# Rezoning Transportation Analysis

Petition Number: 2018-137

## Revision Log:

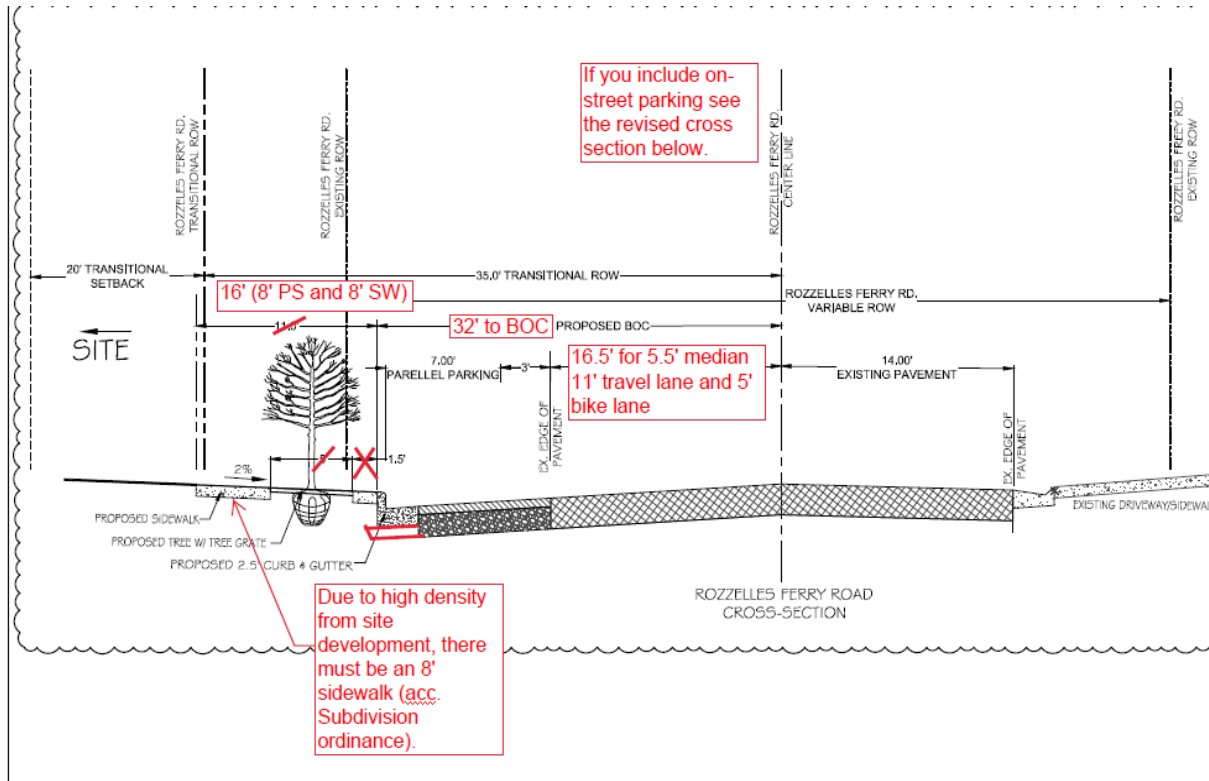
3. The petitioner shall revise the site plan and conditional note(s) to construct an ADA parking space either along Rozzelles Ferry Road or Lakewood Avenue.
4. The petitioner shall revise the site plan and conditional note(s) to construct an ADA ramp to cross Lakewood Avenue. CDOT is requesting two ADA ramps on the opposite side of site at the corner of Lakewood Avenue and Rozzelles Ferry Road to comply with the Lakewood Neighborhood Plan. See picture below.
